Access Compliance Report

Public Rights-of-Way

(Curb Ramps)

Intersection ID: 22351	Main Street: NATIONS_FORD_RD	Cross Street: WINDSONG_DR	Location: N
ADA ID: A071BB72E52B	Ramp Type: PerpDiag	Initial Pass/Fail: Fail	Overall Compliance: No
			Severity Score: 26.25

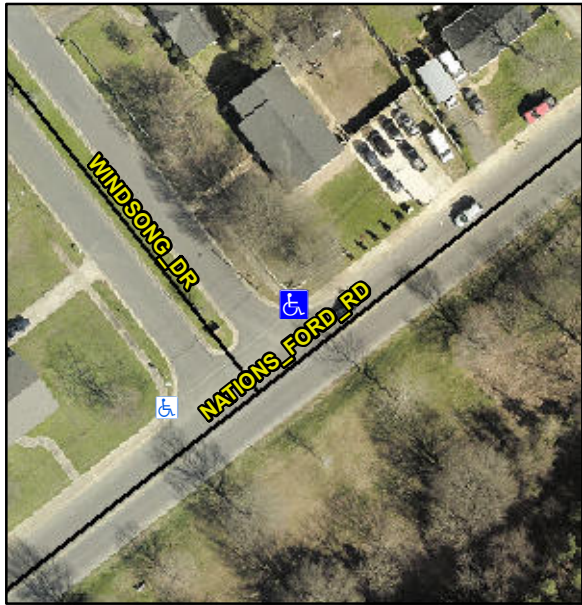
Codes/Mitigation Info/Possible Solution			Field Measurements/Component Compliance					
	Possible Solutions:		Compliance	Description	Data	Compliance	Description	Data
	Remove & Replace Curb Ramp With Two New Directional Ramps or Equivalent.		N/A	Ramp Length (in)	61.0	No	Ramp Slope (%)	13.6
			Yes	Ramp Width (in)	48.0	No	Ramp XSlope (%)	3.8
			N/A	Flare Type LT	N/A	N/A	Flare Type RT	N/A
			N/A	Flare Slope LT (%)	N/A	N/A	Flare Slope RT (%)	N/A
			N/A	Flare Traversable LT?	N/A	N/A	Flare Traversable RT?	N/A
			N/A	Landing Length (in)	N/A	N/A	DWS Provided?	N/A
			N/A	Landing Width (in)	N/A	N/A	DWS Contrast?	N/A
			N/A	Landing Slope (%)	N/A	N/A	DWS Length (in)	N/A
			N/A	Landing X Slope (%)	N/A	N/A	DWS Full Width?	N/A
Surveyor Notes:	N/A		N/A	Landing Curb? (Y/N)	N/A	N/A	DWS Offset (in)	N/A
			N/A	Shared Landing?	N/A			
	PROW/ADA:		N/A	Gutter Ponding?	N/A	N/A	Gutter Slope (%)	N/A
	Not Found, R304.2.2, R304.5.3		N/A	Gutter Lip Ht (in)	N/A	N/A	Gutter X Slope (%)	N/A

N/A	Painted X Walk1?	No	N/A	Painted X Walk2?	No
				X Walk 1 Direction	To SW		X Walk 2 Direction	To SE
			N/A	X Walk 1 Width (in)	N/A	N/A	X Walk 2 Width (in)	N/A
				X Walk 1 Slope (%)	3.0		X Walk 2 Slope (%)	5.5
				X Walk 1 X Slope (%)	3.6		X Walk 2 X Slope (%)	0.3
			N/A	Ramp inside XWalk1?	N/A	N/A	Ramp inside XWalk2?	N/A
			Road Slope (%)	1.7	N/A	Clear Space?	N/A	
			Road X Slope (%)	6.4	N/A	Clear Space to XWalk (in)	N/A	
		N/A	Any Obstructions?	N/A	N/A	Storm Grate/Utility Hazard?	N/A	
			Obstruction Type			Storm Grate/Utility Type		
					N/A			N/A
						Yes	Surface Condition? (G/P)	Good
